# Planning Board Work Session 2 | July 27<sup>th</sup> | 2017

**M** Metro Stations     Plan Boundary     Parkland

# Planning Board Modifications

Figure 19: Recommended height diagram

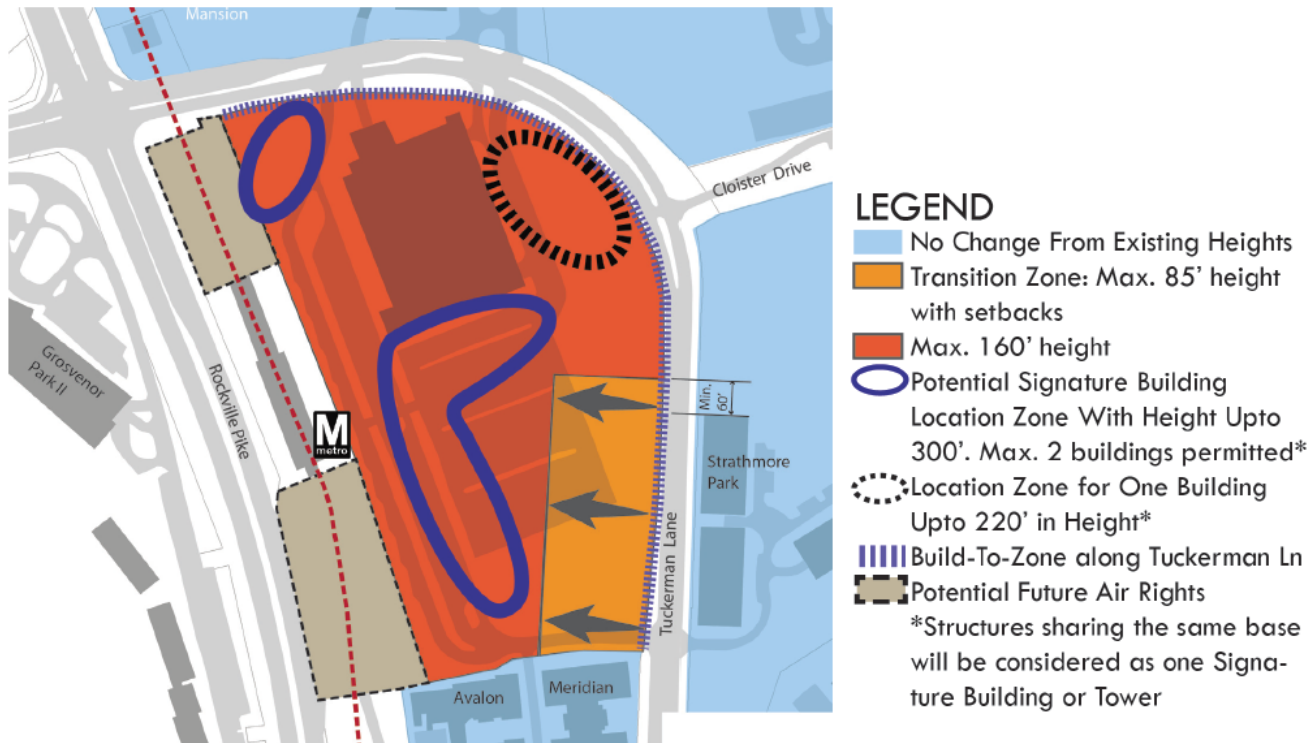
- Allow two signature buildings up to ~~260~~300 feet high along Rockville Pike.
- Allow one building of up to 220 feet high on Tuckerman Lane.

- Change Heights diagram to reflect 300' heights for signature tower, and 220' tower on Tuckerman Lane

Figure 19: Recommended height diagram

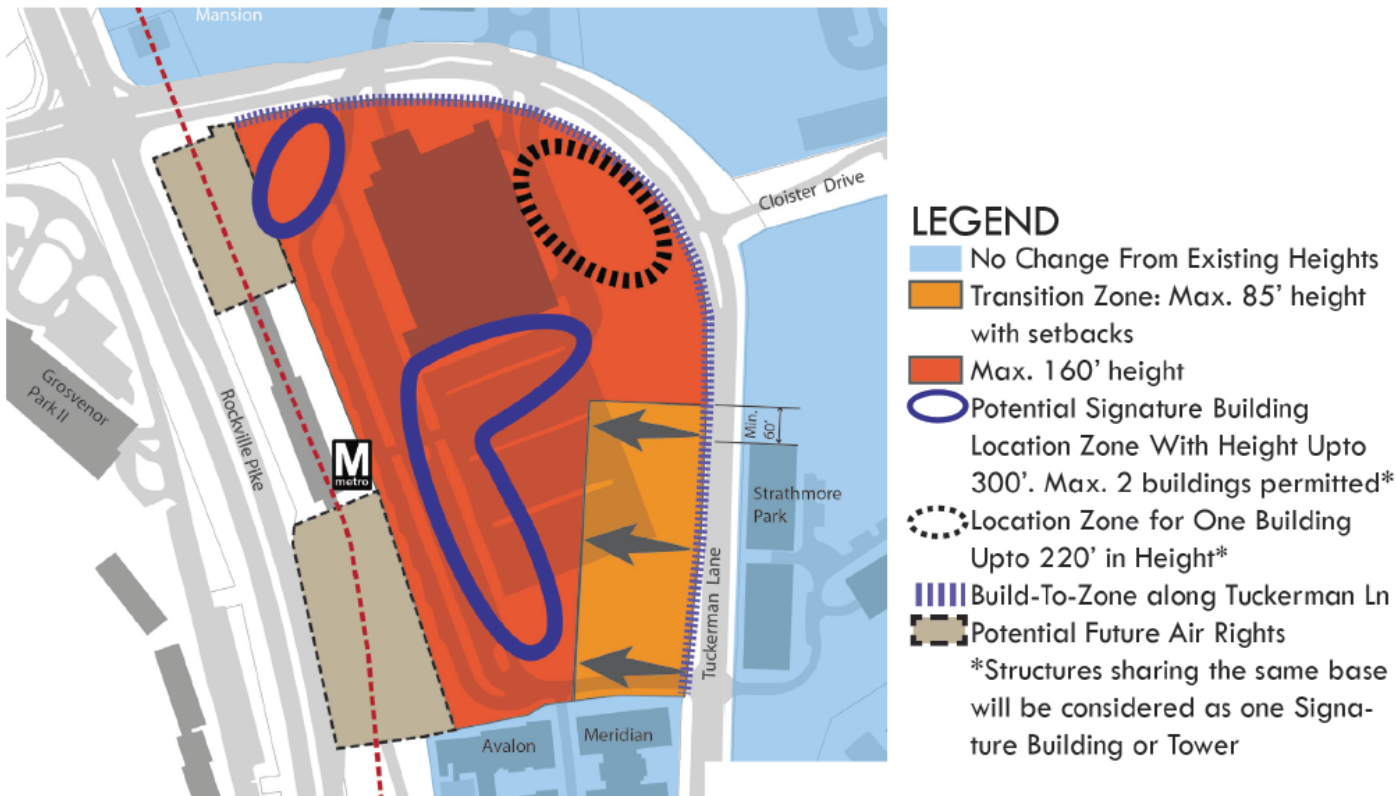
- Change heights diagram to show a reduced transition zone boundary

## Chapter 3: Urban Design and Design Guidelines – page 34

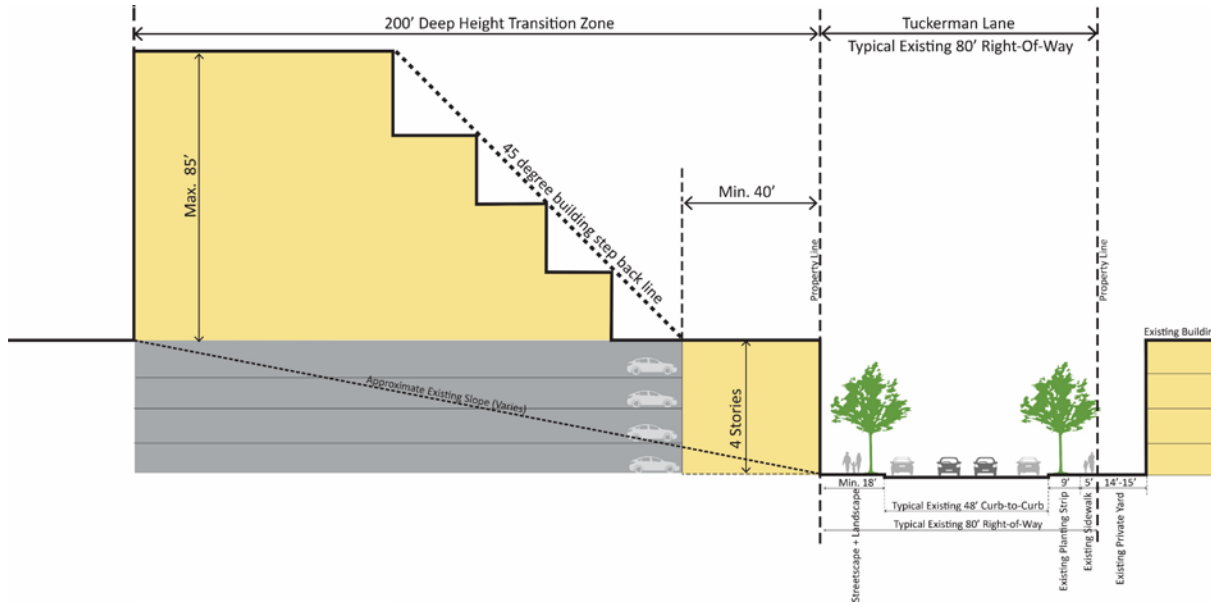
- Create a Civic Green of ~~minimum~~ 1.25 acres at the Metro site. The exact size and configuration of the civic green will be determined during the regulatory review of the project.
- Create a plaza at the station entrance with retail and other active uses. Include features such as hardscape, tree plantings for shade, movable seating, interesting lighting for nighttime use, and highly transparent ground floor facades. Retail Plaza could be designed as a part of the Civic Green.

# Transition Zone Diagram

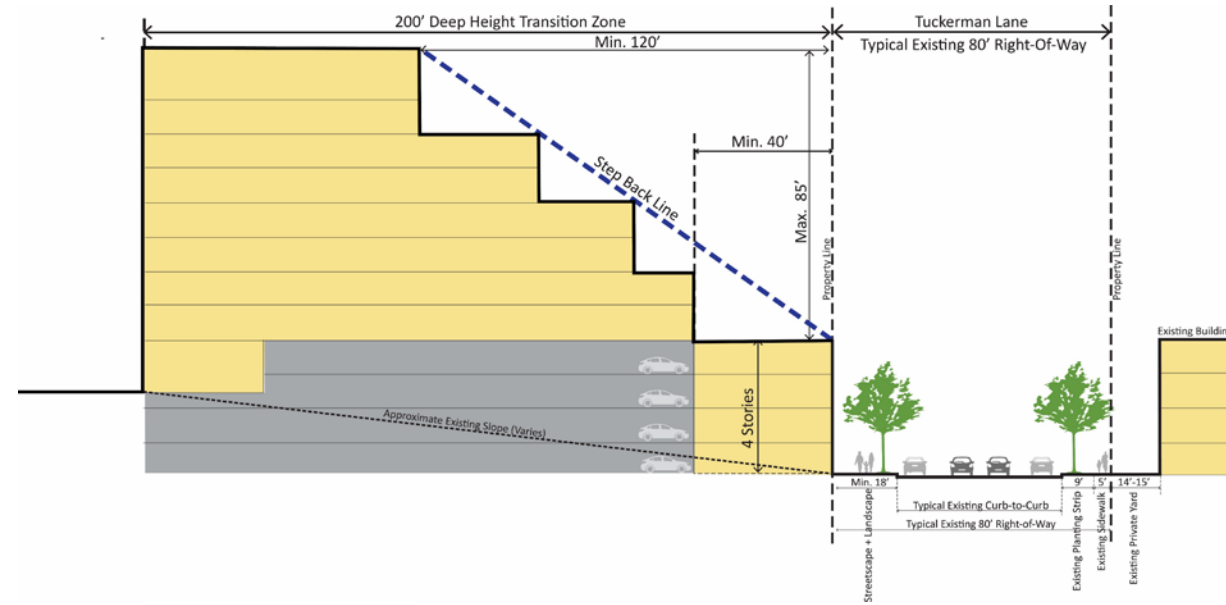
Transition Zone Diagram from the Public Hearing Draft

Revised Transition Zone Diagram
